Re: **Certification for Permanent Certificate of Occupancy (C.O.)**
Animal Humane Shelter of NM, ***PHASE I ONLY*** **(L-19/D016)**
615 Virginia St.
Engineer's Stamp dated 05-08-13

Re: Animal Humane Shelter of NM, 615 Virginia Street SE,
Traffic Circulation Layout, Engineer's Stamp dated 10-17-12 (L19-D016)

Re: Animal Humane Shelter of NM, 615 Virginia Street SE,
Traffic Circulation Layout, Engineer's Stamp dated 9-28-12 (L19-D016)

1 ARCHITECTURAL SITE PLAN
SCALE: 1" = 20'-0"

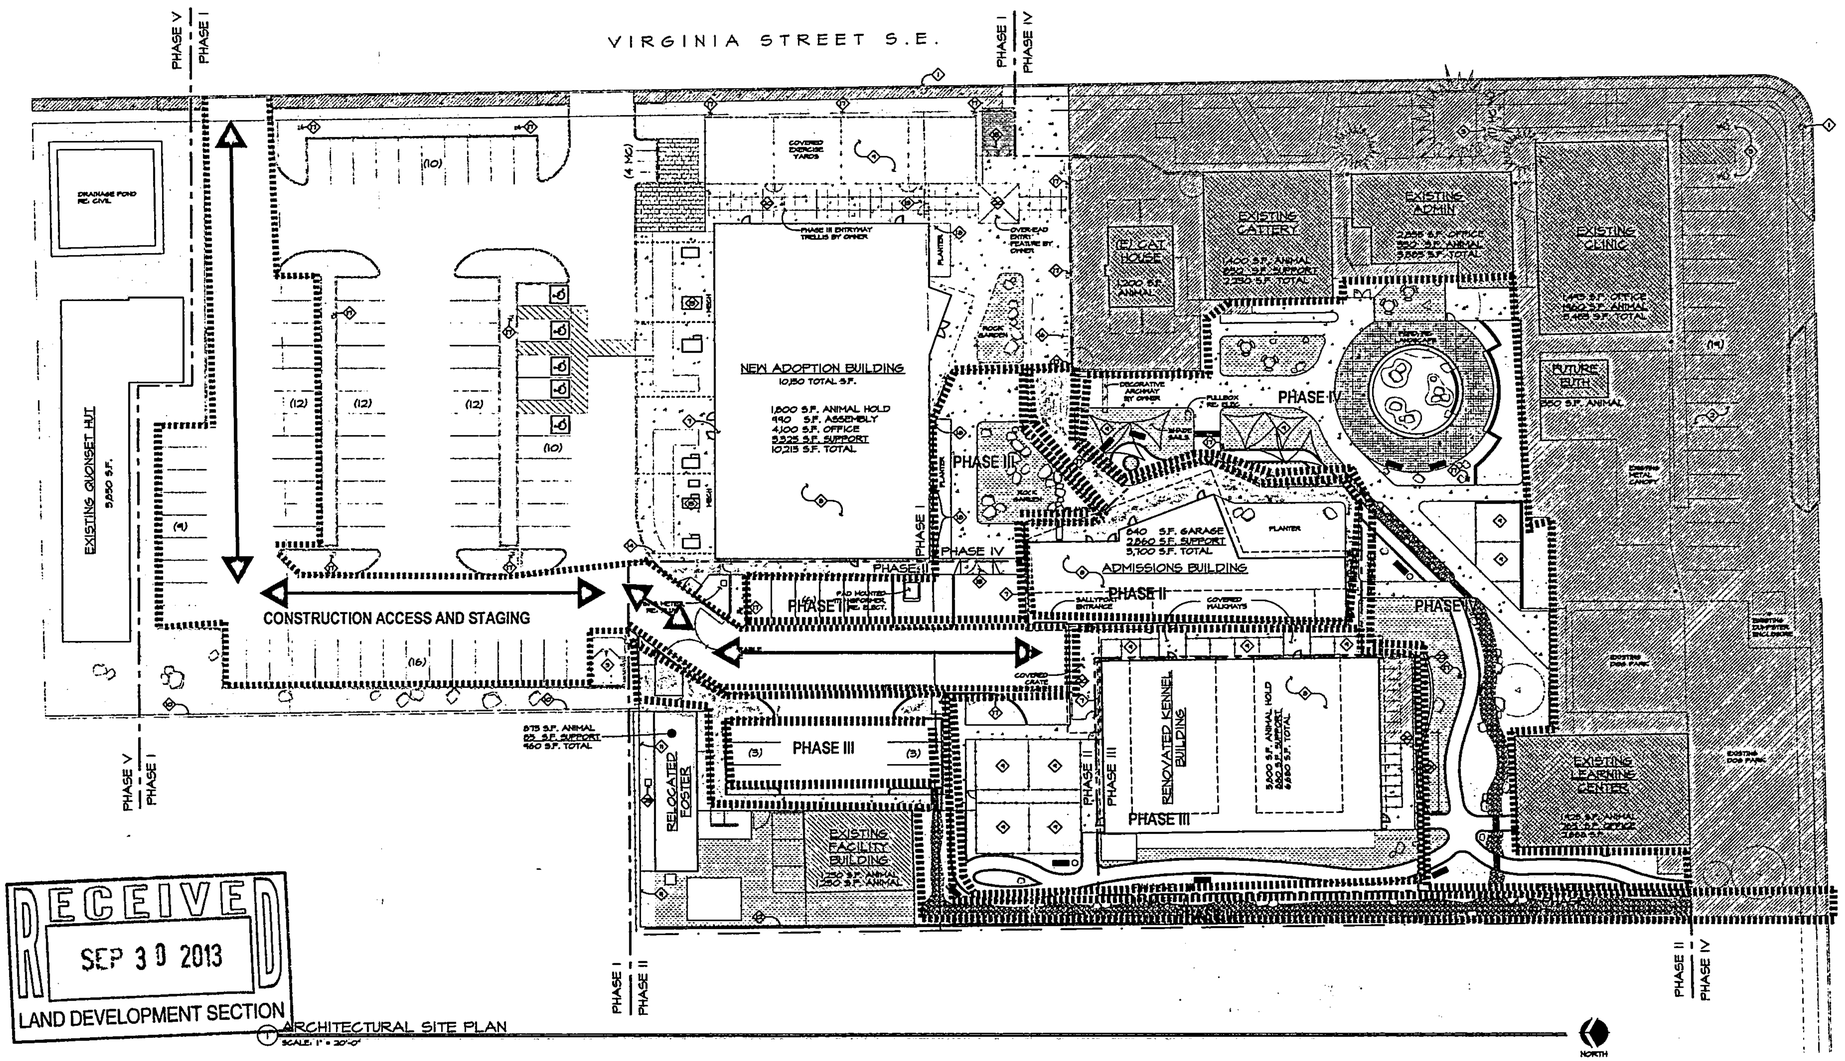
Exceptions: Phase II includes the sidewalk on east side of New Intake Building and connecting sidewalk to New Adoption Building and sidewalk south of Relocation Foster Building as shown on attached drawing.
